Subject: Issuance of Amendment No. 11 to Facility Operating License No. NPF-38
for Waterford 3

WATERFORD STEAM ELECTRIC STATION, UNIT 3

AMENDMENT TO FACILITY OPERATING LICENSE

SAFETY EVALUATION BY THE OFFICE OF NUCLEAR REACTOR REGULATION
SUPPORTING AMENDMENT NO. 11 TO FACILITY OPERATING LICENSE NO. NPF-38

Figure 3.1-0

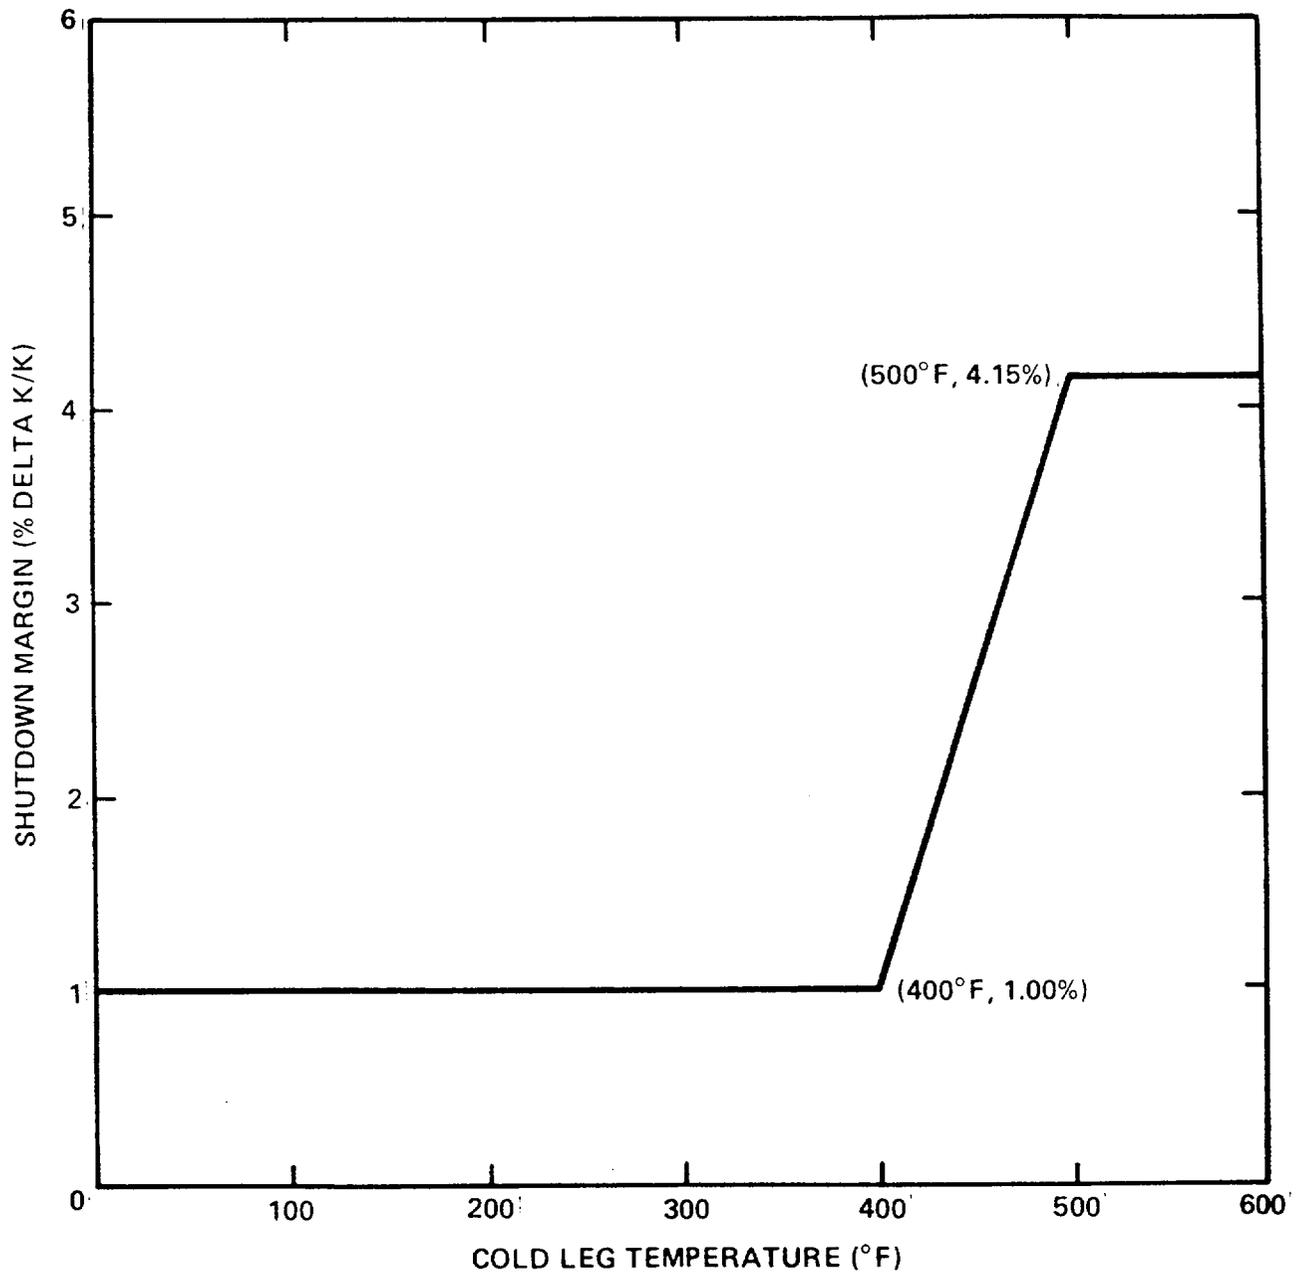
3.1.1.2 The SHUTDOWN MARGIN shall be greater than or equal to that shown in Figure 3.1-0.

The most significant change due to the proposed amendment is the reduction in required shutdown margin during Modes 2 through 5 when all full-length CEAs are fully inserted into the core. The shutdown margin requirements vary throughout the fuel cycle as a function of fuel depletion and RCS temperature. The most restrictive condition occurs at end of cycle and is associated with a postulated steam line break accident at no-load operating temperature and the resulting uncontrolled RCS cooldown. As the RCS temperature decreases, the potential RCS cooldown and the resulting reactivity transient are less severe and, therefore, the required shutdown margin also decreases. The licensee has proposed a new Figure 3.1-0 which shows the required shutdown margin as a function of cold leg temperature when all CEAs are fully inserted. These shutdown margin requirements vary from 1% at low temperatures to 4.15% for cold leg temperatures above 500°F. The shutdown margin requirements when any CEA is not fully inserted remain the same as current values in Technical Specification 3.1.1.1.

Figure 3.1 - 1A

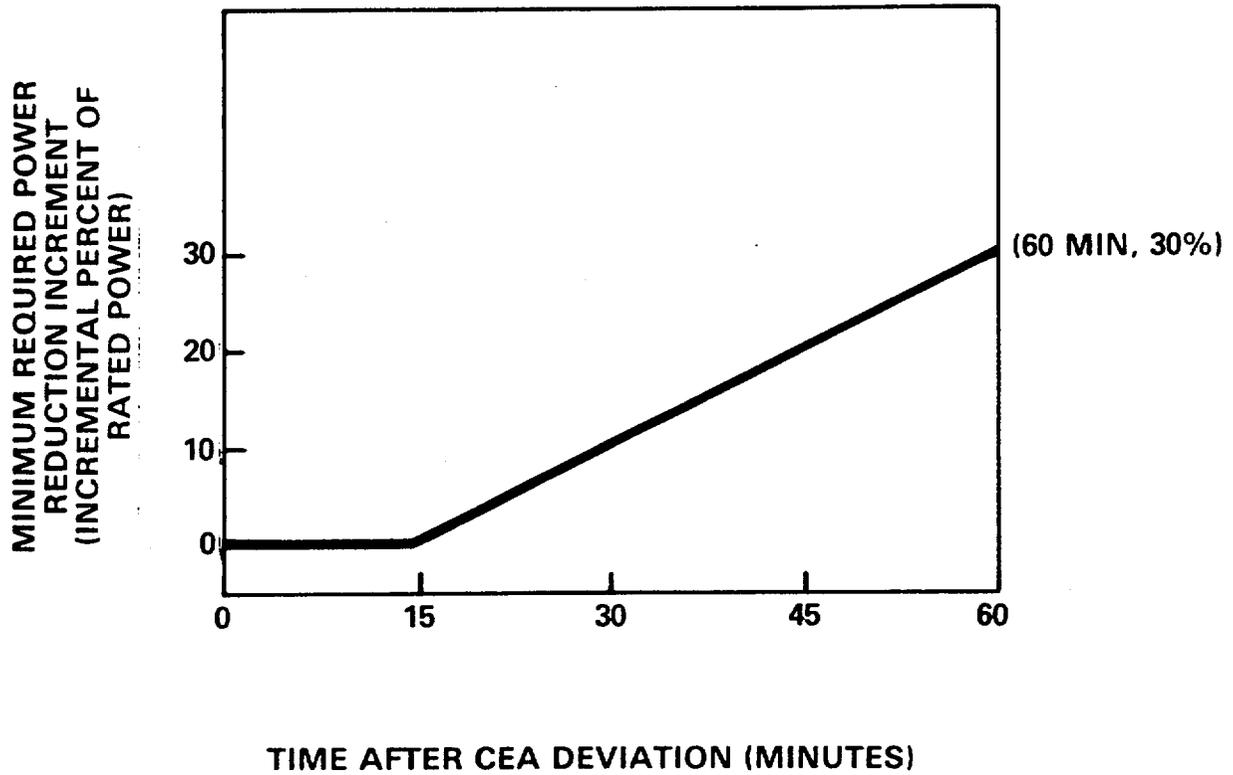
- c. With one full-length or part-length CEA misaligned from any other CEA in its group by more than 19 inches, operation in MODES 1 and 2 may continue, provided that core power is reduced in accordance with Figure 3.1-1A and that within 1 hour the misaligned CEA is either:

- d. With one or more full-length or part-length CEAs misaligned from any other CEAs in its group by more than 7 inches but less than or equal to 19 inches, operation in MODES 1 and 2 may continue, provided that core power is reduced in accordance with Figure 3.1-1A and that within 1 hour the misaligned CEA(s) is either:

The proposed change would revise ACTION statements "c" and "d" to Technical Specification 3.1.3.1, "Moveable Control Assemblies, CEA Position". The reason for this change is to impose new requirements on power reduction during the period from 15 minutes to one hour following a full or part-length CEA misalignment. This change would reduce the inward CEA deviation penalty factors currently provided by the CEA Calculators (CEACs) to the CPCs to a value of 1.0. The reduction of these penalty factors will reduce the sensitivity of the CPCs to CEA drops and to electronic noise which can be interpreted in the logic as a major CEA deviation and will, therefore, eliminate some unnecessary reactor trips.

Required Power Reduction after Single CEA Deviation*

*When core power is reduced to 60% of rated power per this limit curve, further reduction is not required by this specification.
